# NEAR-FIELD DRIPPING AND THERMAL MODELS

**May 25, 1999**  
**San Antonio, Texas**

**DOE/NRC Technical Exchange on**  
**Total System Performance Assessments for Yucca Mountain**

# BOUNDARY LAYER FORMED WITH MEDIAN

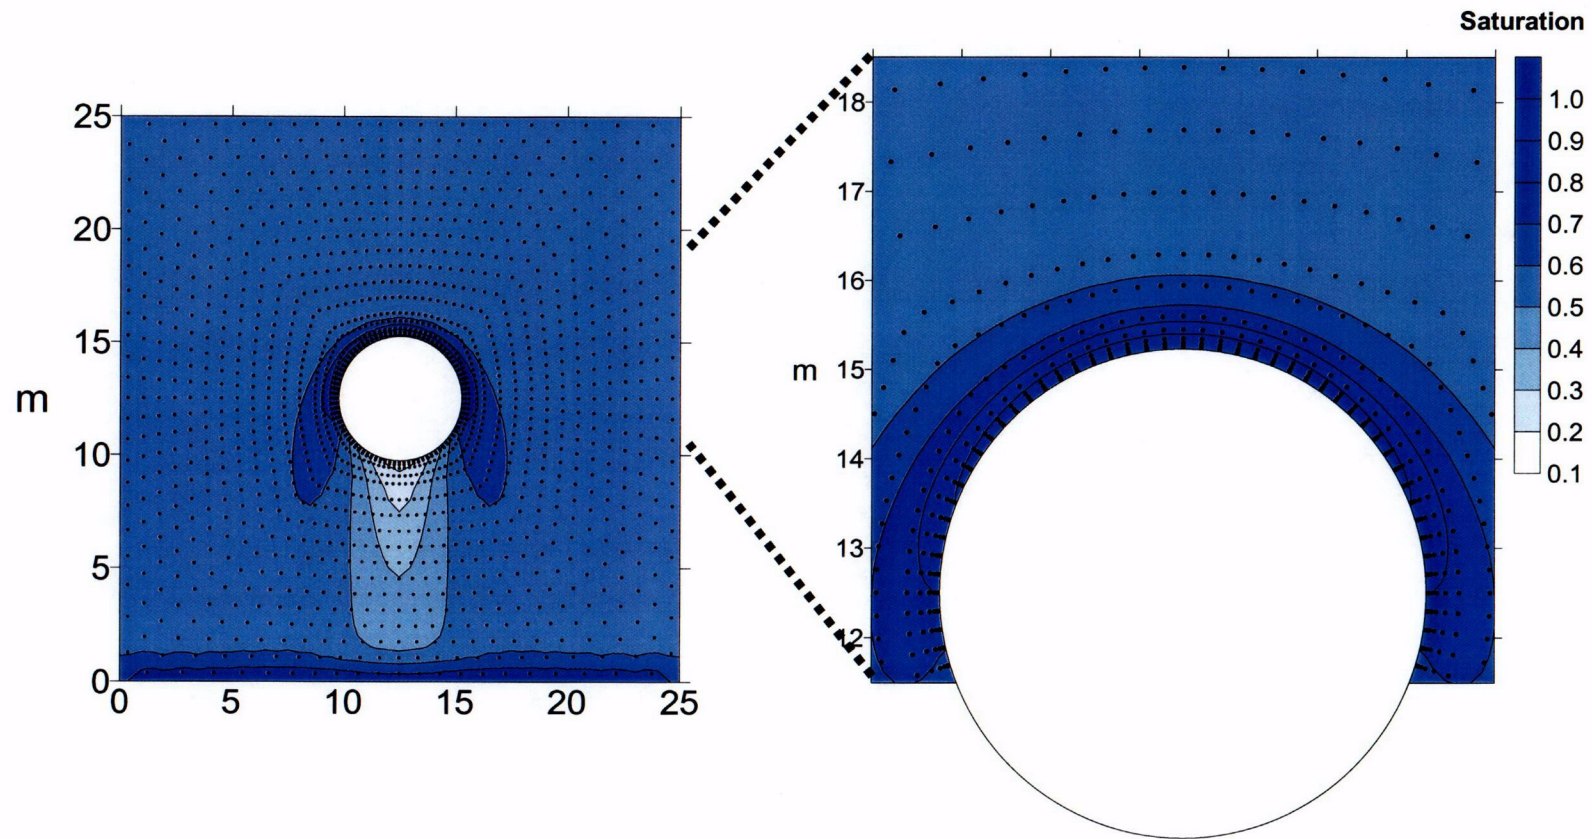
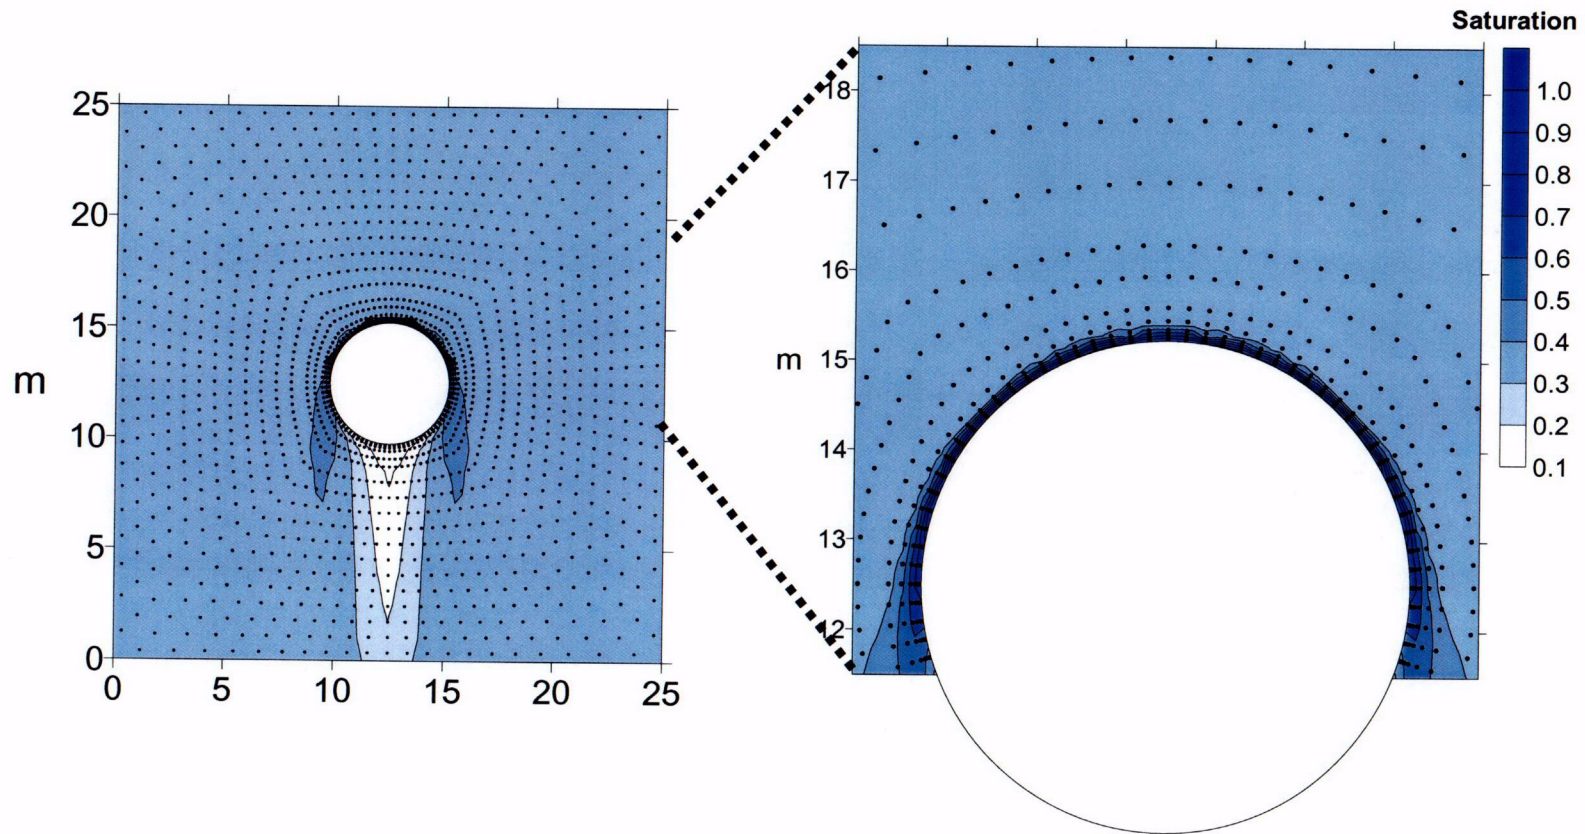
- **Model Scales and Fracture Properties**
  - **Heterogeneity in the alpha parameter within the boundary layer may be important**
- **Drift Degradation and Wall Irregularity: What Happens If the Boundary Layer Shape Is Perturbed?**

# FACTOR BY WHICH THRESHOLD PERCOLATION FLUX IS DECREASED

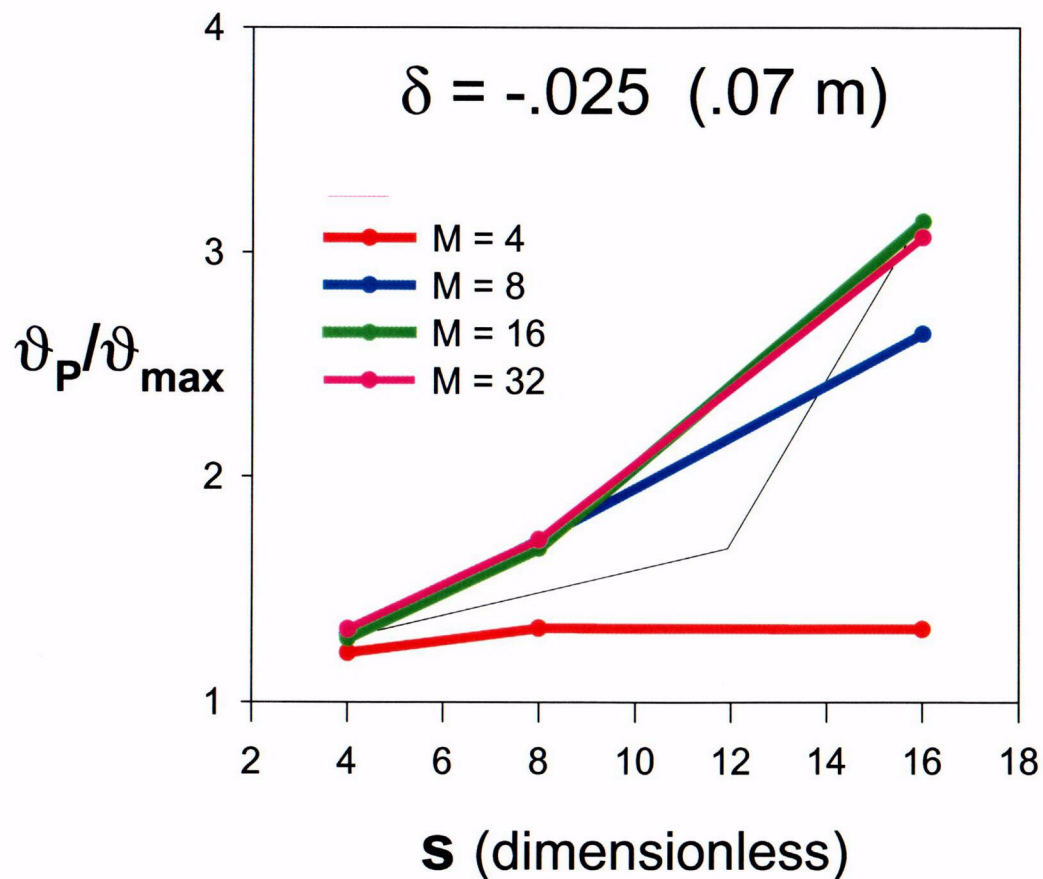
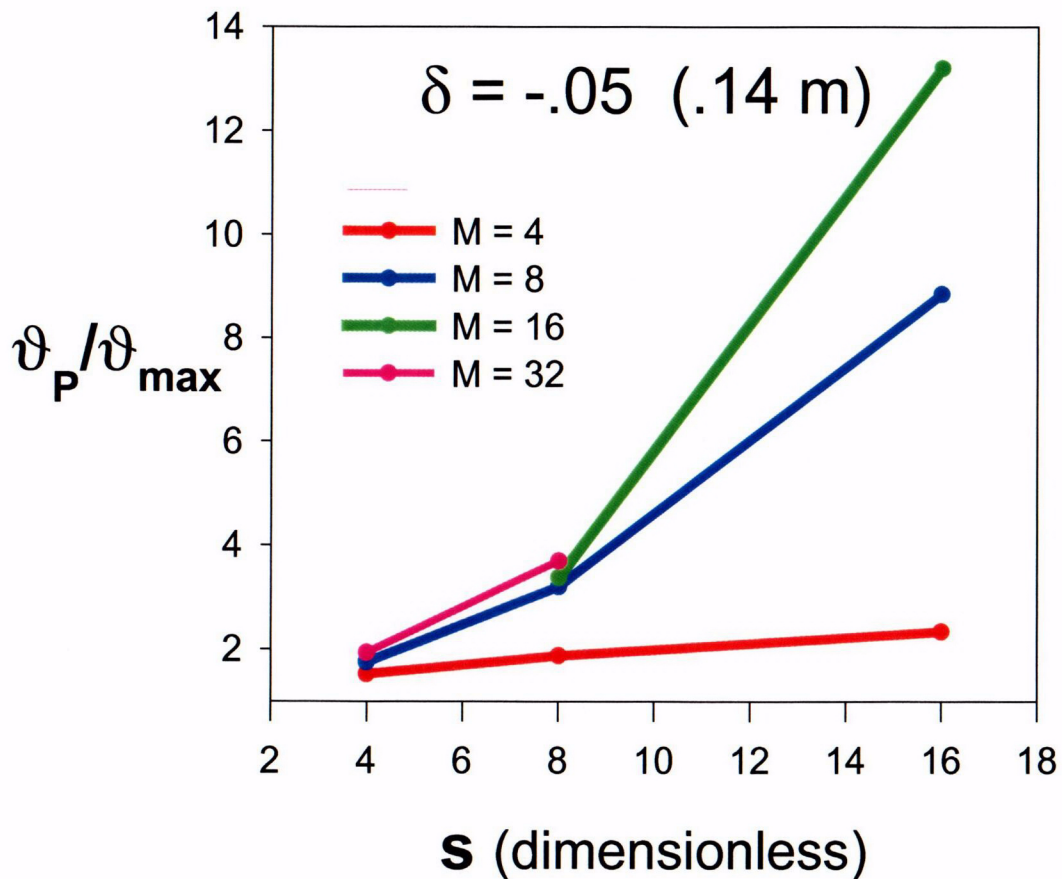
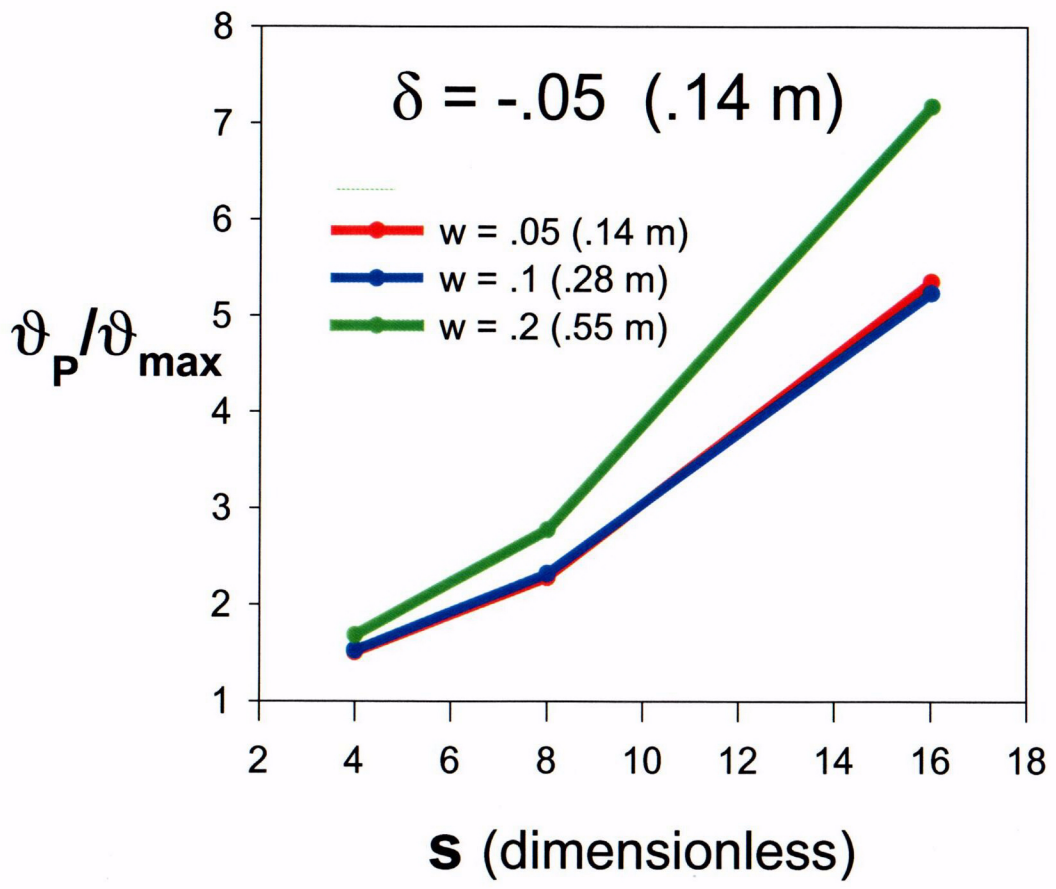
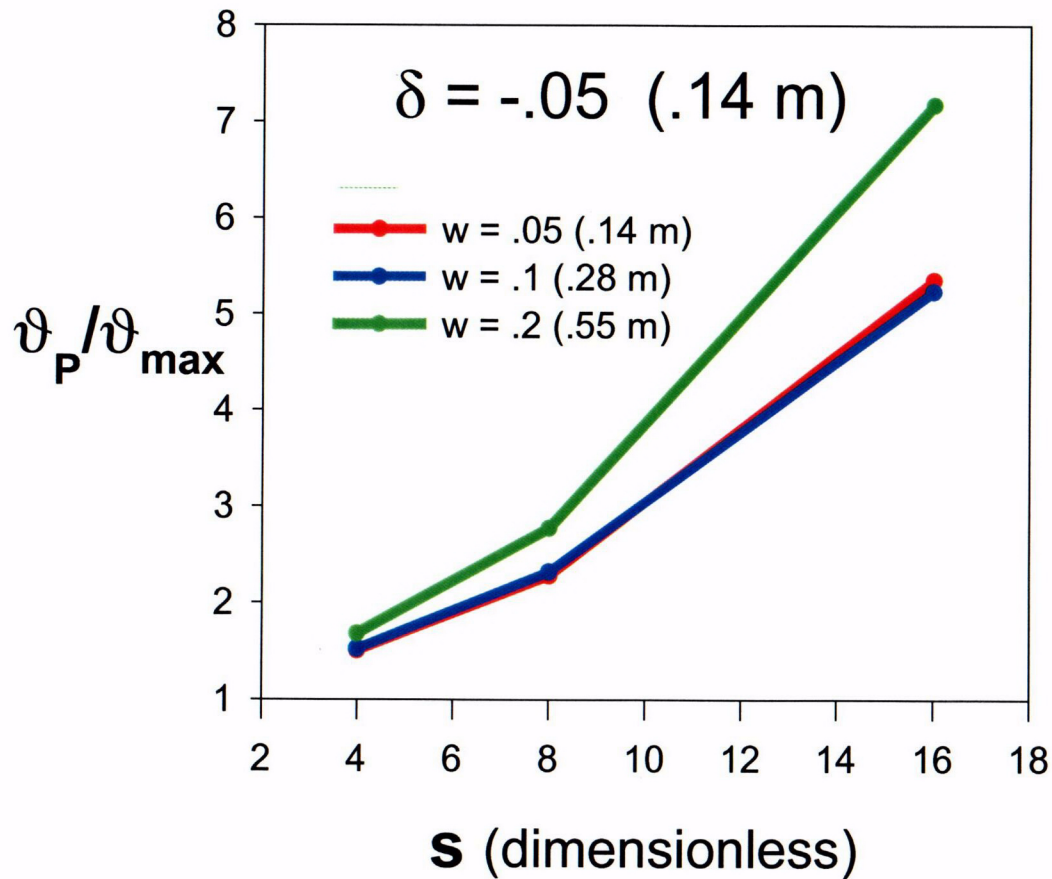
**Irregularities in the Range of 15 cm Can Result in Order of Magnitude Decreases in Threshold Percolation Flux for  $s$  Less Than 16. Note the Dramatic Increase in This Reduction Factor With Increasing  $s$ . Larger  $s$  Corresponds to the Larger  $\alpha$ , (i.e., smaller characteristic length scale, representative of the larger vertical fractures.)**
